DESCRIPTIVE REPORT

Registry Number: **H11920**

Sub-locality: Gay Head to Cedar Tree Neck

**Project OPR-B307-TJ-08
 Gay Head to Cedar Tree Neck
 Rhode Island Sound and Approaches, RI and MA
 Scale 1:10,000
 July 15th – September 08th 2008
 NOAA Ship *THOMAS JEFFERSON***

Figure 1.1.1

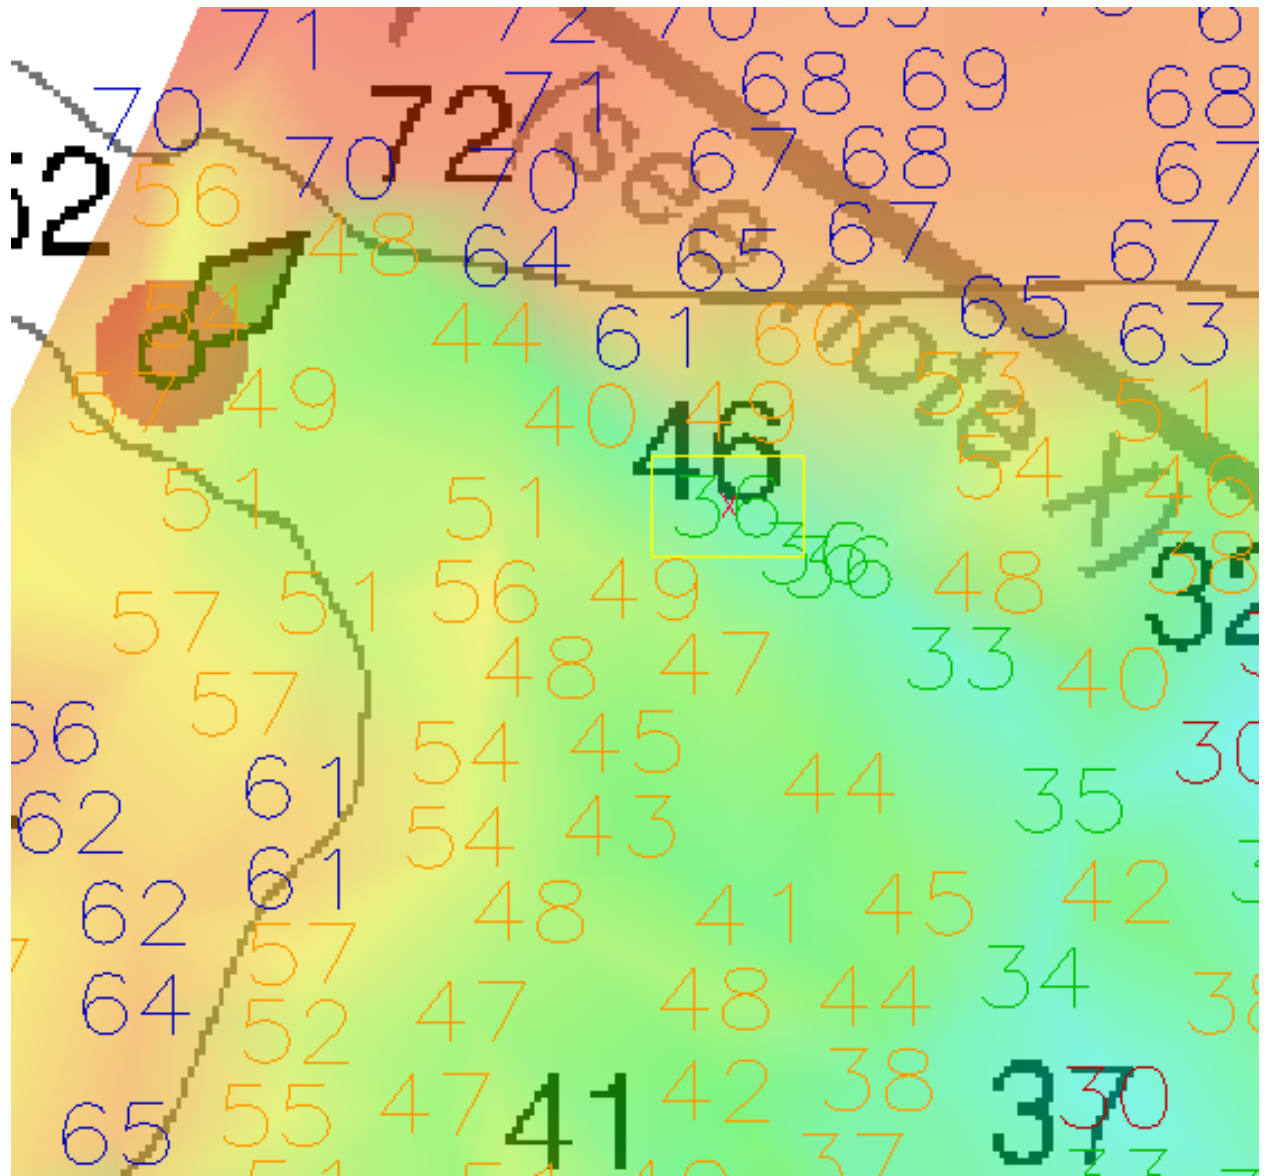
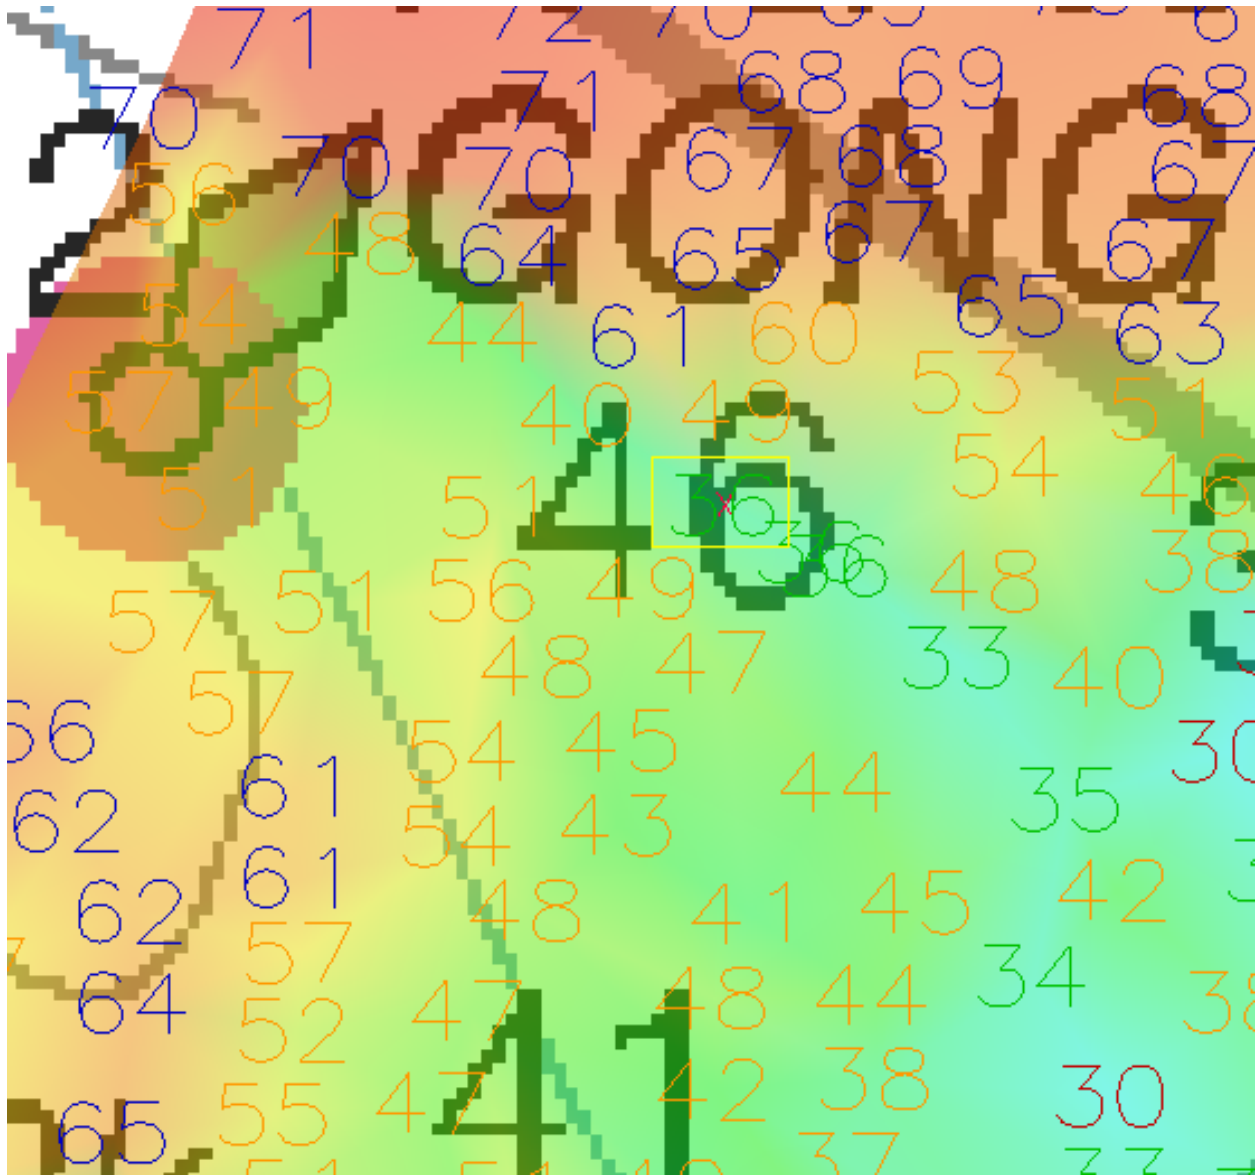
A 36 ft sounding on a sand wave was found on a 46 ft charted depth. The sounding was acquired by Reson 8101 multibeam and corrected to MLLW using observed water levels. Note locations of sounding on Chart 13233_1 and 13218_1. Final Verified Water Levels and TCARI zonig were applied and resolved the sounding to 38 ft.

Concur w/ clarification DToN was submitted to MCD 11/17/2008. Consider charting a seabed area for the sandwaves in this region.

Figure 1.2.1

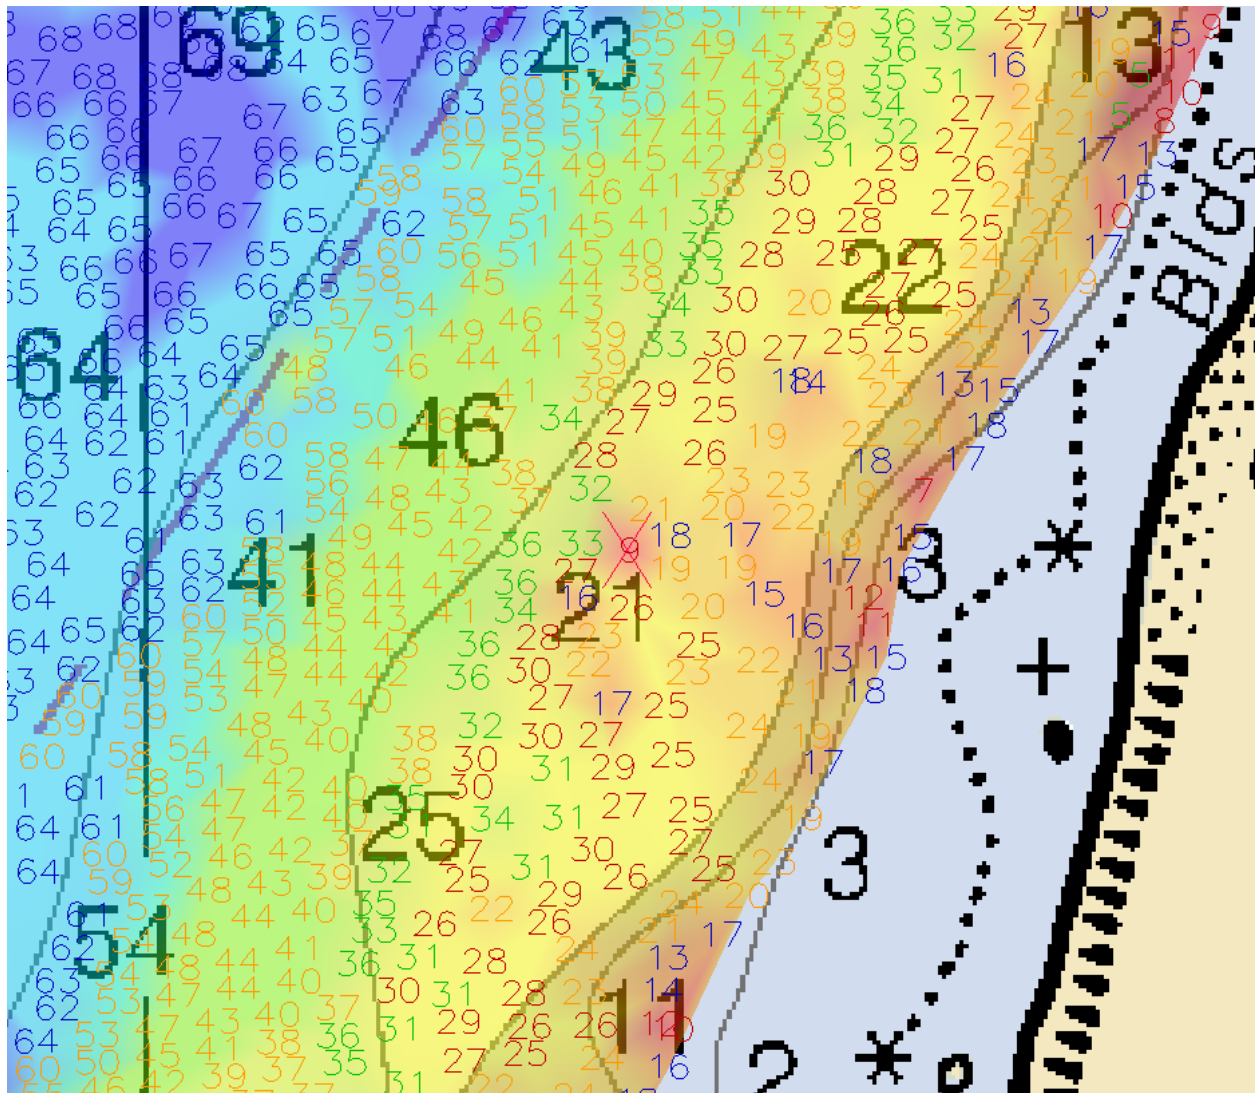
Uncharted rock. The sounding was acquired by Reson 8125 multibeam and corrected to MLLW using observed water levels. Note locations of sounding on Chart 13233_1 and 13218_1. Final Verified Water Levels and TCARI zonig were applied and resolved the sounding to 9.48ft(2.89m).

Concur w/ clarification DToN was submitted to MCD 11/17/2008.Retain as charted.

Figure 1.3.1

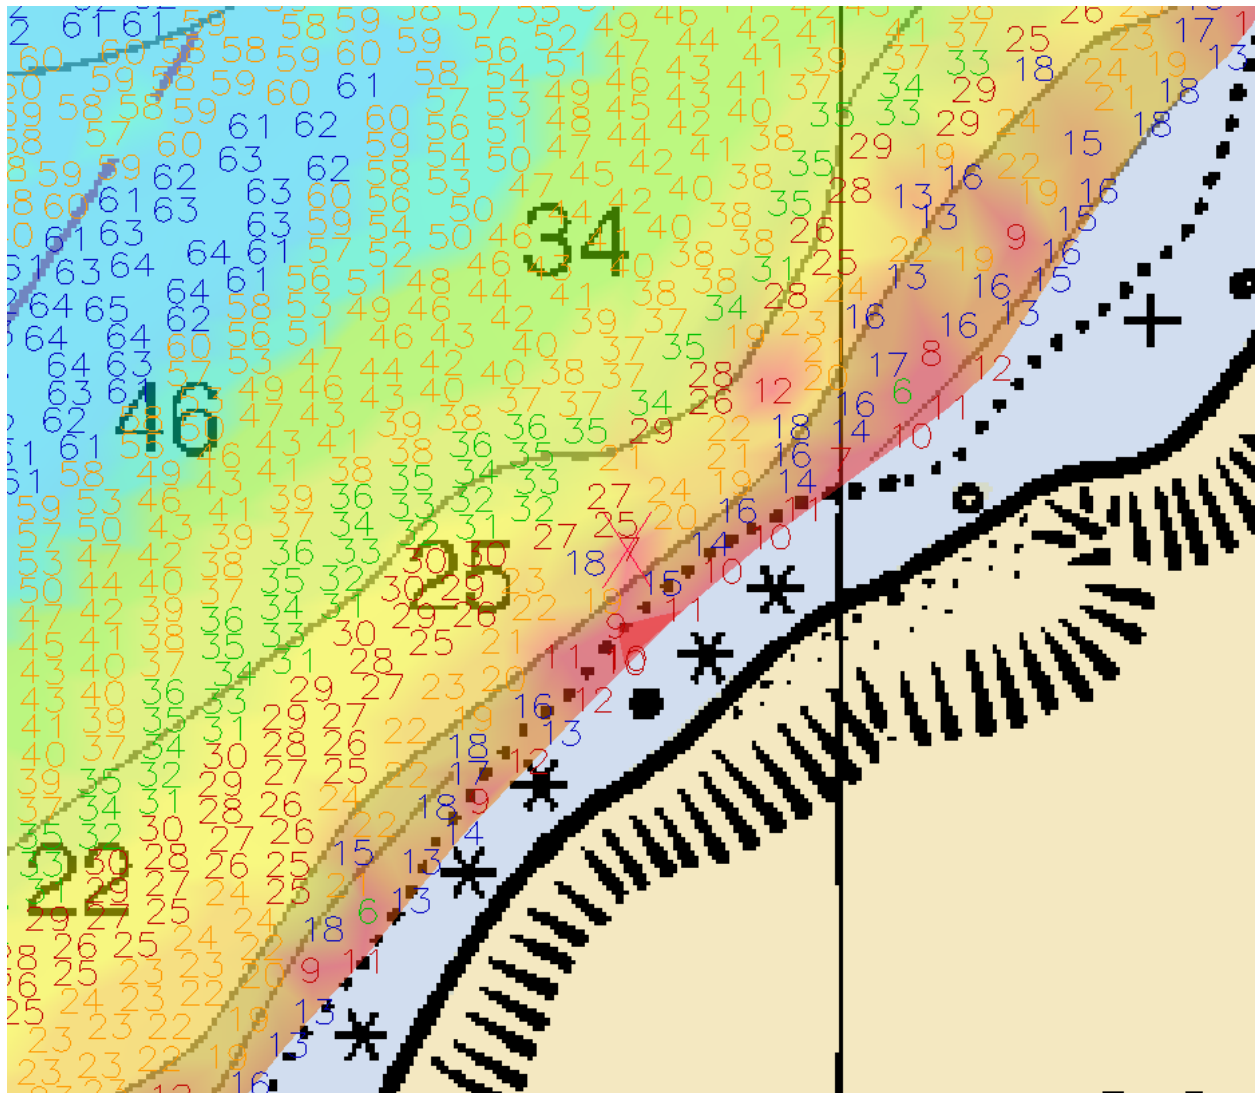
Uncharted rock. The sounding was acquired by Reson 8125 multibeam and corrected to MLLW using observed water levels. Note locations of sounding on Chart 13233_1 and 13218_1. Final Verified Water Levels and TCARI zonig were applied and resolved the sounding to 7.49ft(2.28m)

Concur w/ clarification DToN was submitted to MCD 11/17/2008.Retain as charted.

Figure 1.4.1

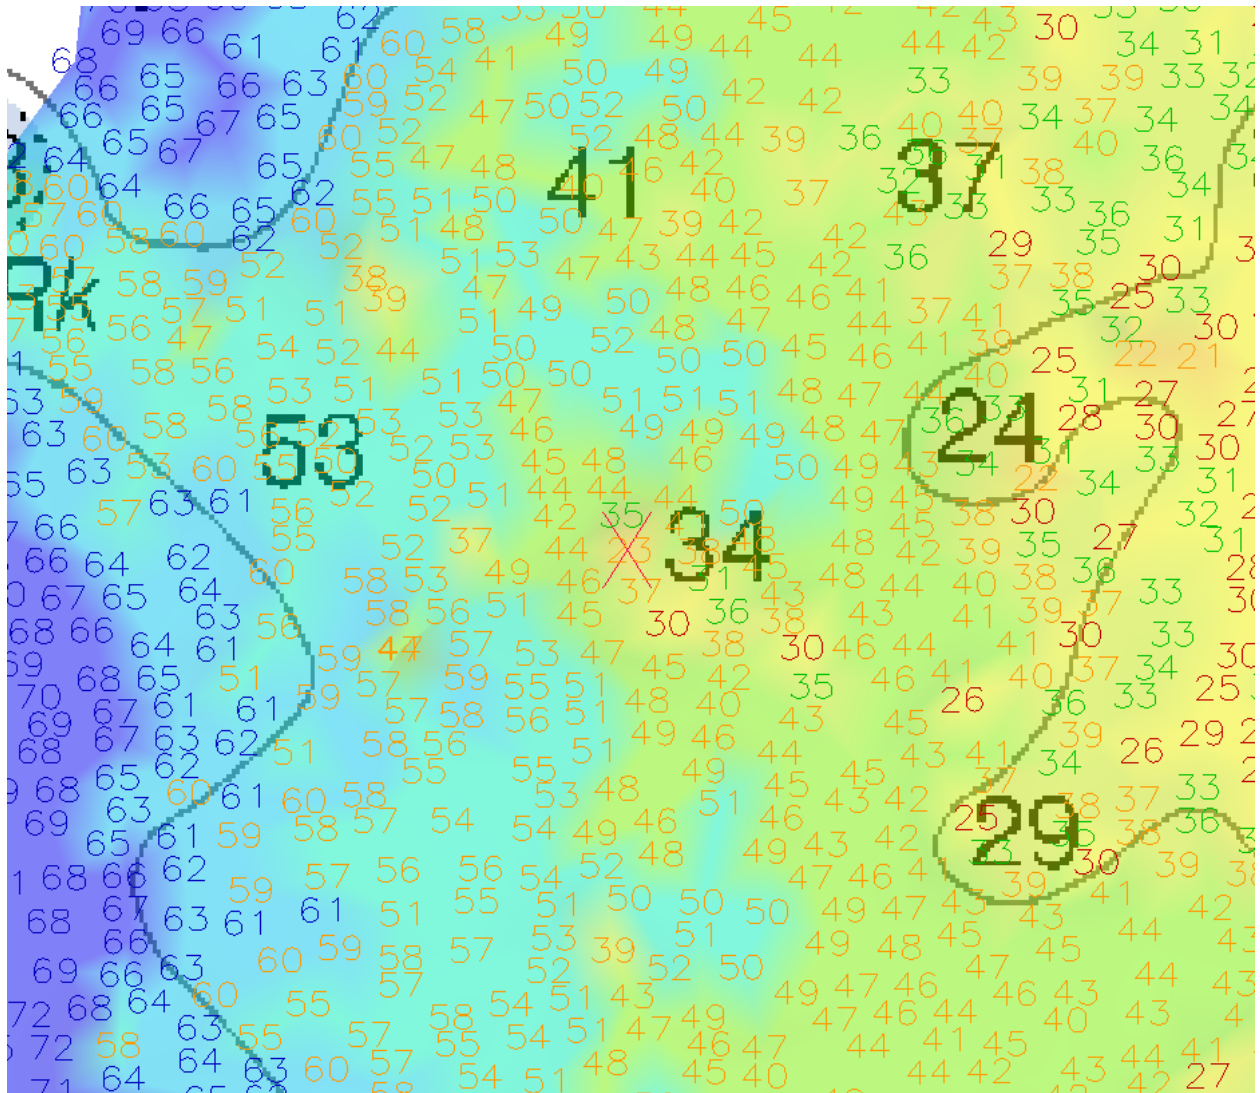
Uncharted rock. The sounding was acquired by Reson 8125 multibeam and corrected to MLLW using observed water levels. Note locations of sounding on Chart 13233_1 and 13218_1. Final Verified Water Levels and TCARI zonig were applied and resolved the sounding to 23.23 ft (7.08m).

Concur w/ clarification DToN was submitted to MCD 11/17/2008.Retain as charted.

Figure 1.5.1

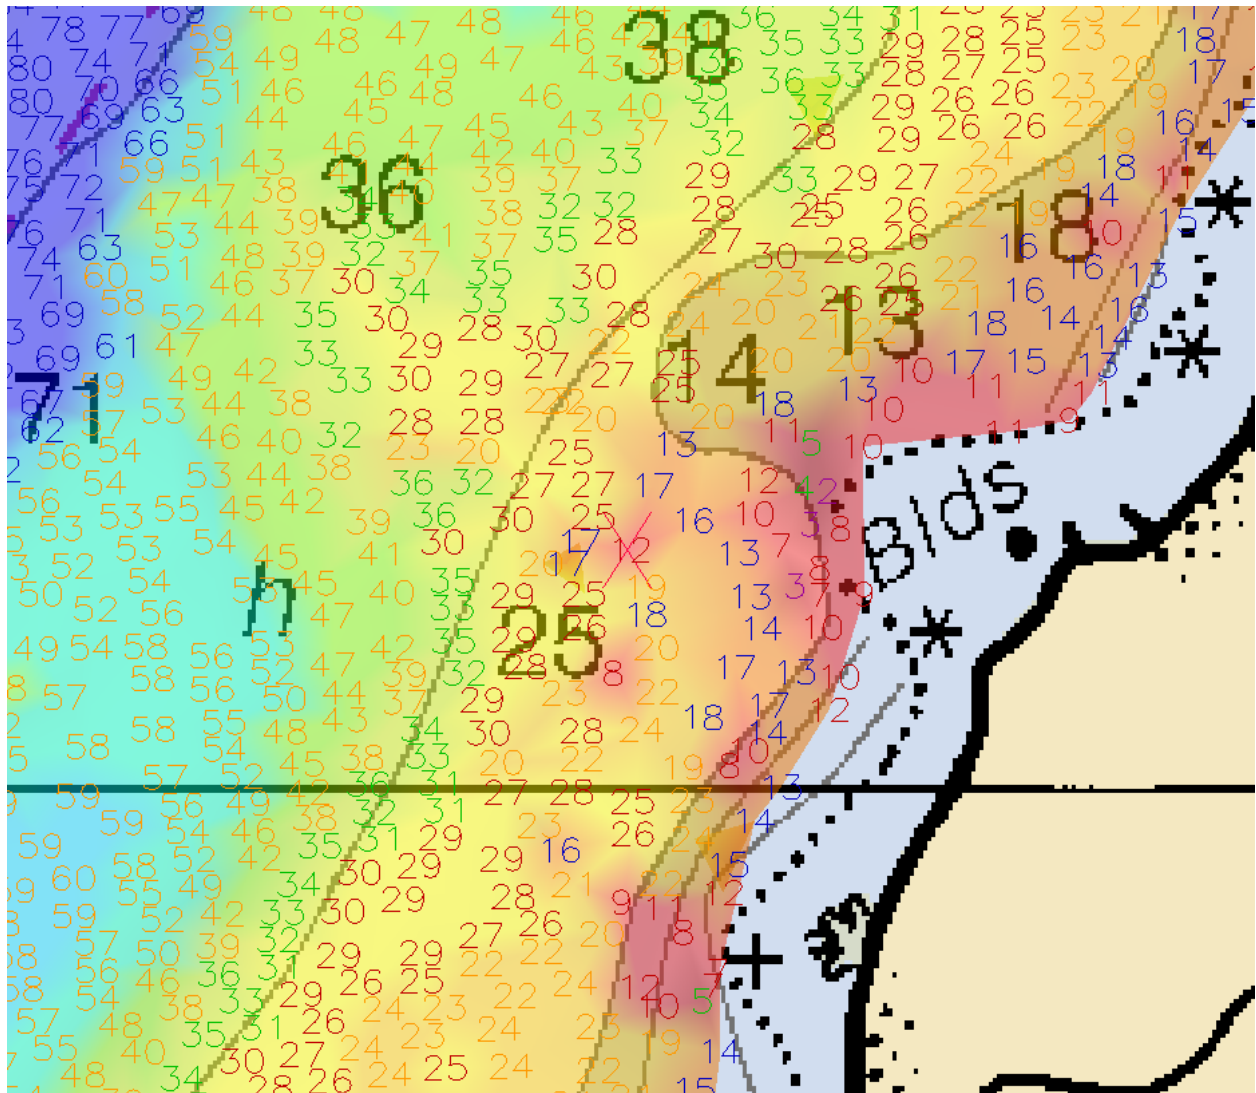
Uncharted rock. The sounding was acquired by Reson 8101 multibeam and corrected to MLLW using observed water levels. Note locations of sounding on Chart 13233_1 and 13218_1. Final Verified Water Levels and TCARI zonig were applied and resolved the sounding to 12.07ft(3.68m).

AHB recommends 12-ft DtoN to be retained as charted.

Figure 1.5.1

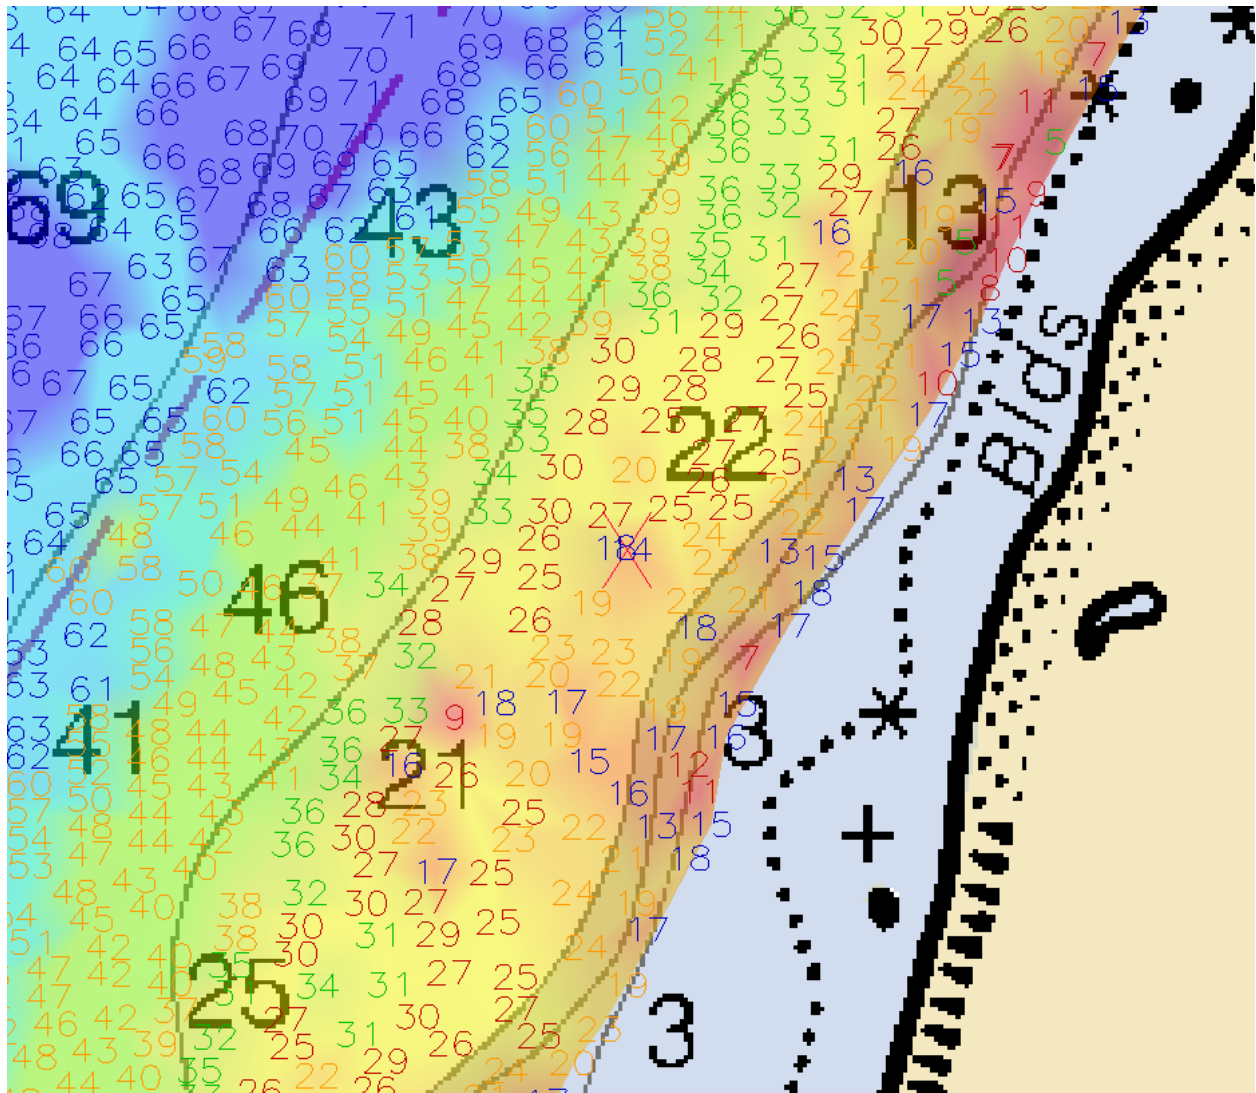
AHB recommends charting 10 Ft UWTROC and updating chart w/ current surveyed soundings
